From: Mark Leyse <markleyse@gmail.com>
Sent: Sunday, November 22, 2015 8:10 AM
To: Mohseni, Aby
Cc: Gilles, Nanette; Moore, Johari; Patrick.Castlernan@nrc.gov; Frazier, Alan; Cabbage, Amy; Bloomer, Tamara; Krsek, Robert; bobleuse@aol.com; shadis@prexar.com; Burnell, Scott; Bladey, Cindy; DeJesus, Anthony; Inverso, Tara; dlochbaum@ucsusa.org; elyman@ucsusa.org; mmckinzie@nrdc.org; tcochran@nrdc.org; gfettus@nrdc.org; balemayehu@nrdc.org; DBrancato@riverkeeper.org; PGallay@riverkeeper.org; Dean, Bill; Johnson, Michael; jim.riccio@greenpeace.org; Doyle, Daniel; Shane, Raeann; Weber, Michael; Paul Gunter; RulemakingComments Resource; PDR Resource; Diane Curran; Richard Webster; Clay Turnbull; CHAIRMAN Resource; michal_freedhoff@markey.senate.gov
Subject: [External_Sender] Fwd: Status of PRM-50-93/95

Subject: Re: Status of PRM-50-93/95

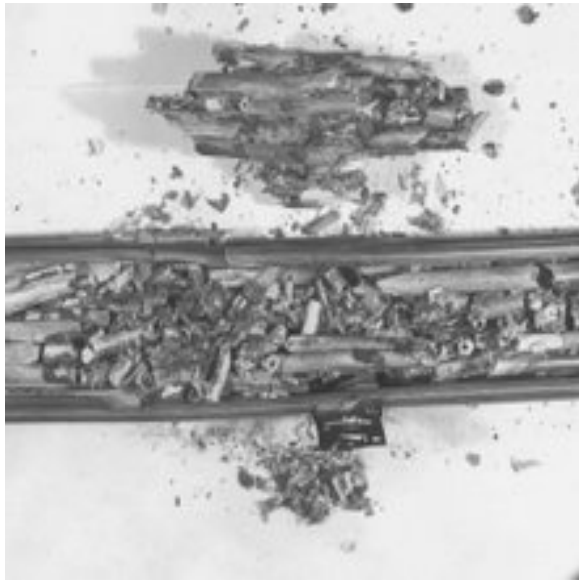
First) Would you please acknowledge that the NRC's TRACE simulation of FLECHT Run 9573 did **not** predict what cladding temperatures would be at the test bundle's **7 foot elevation** at either 18 seconds or 18.2 seconds?

Second) Would you please acknowledge that the NRC's TRACE simulation of FLECHT Run 9573 did **not** predict what steam temperatures would be around the test bundle's **7 foot elevation** at either at 16 seconds, 18 seconds, or 18.2 seconds?

An adequate TRACE simulation of Run 9573 would have predicted cladding temperatures for the test bundle's 7 foot elevation at either 18 seconds or 18.2 seconds. Or an adequate TRACE (or another code or a modified version of TRACE) simulation of Run 9573 would have predicted steam temperatures around the test bundle's 7 foot elevation at either 16 seconds, 18 seconds, or 18.2 seconds.

Such a TRACE simulation of Run 9573 could have been compared to the Westinghouse data indicating that thermal runaway occurred around the test bundle's 7 foot elevation.

The severe-damage zone where thermal runaway occurred--within approximately ± 8 inches at the 7 foot elevation.
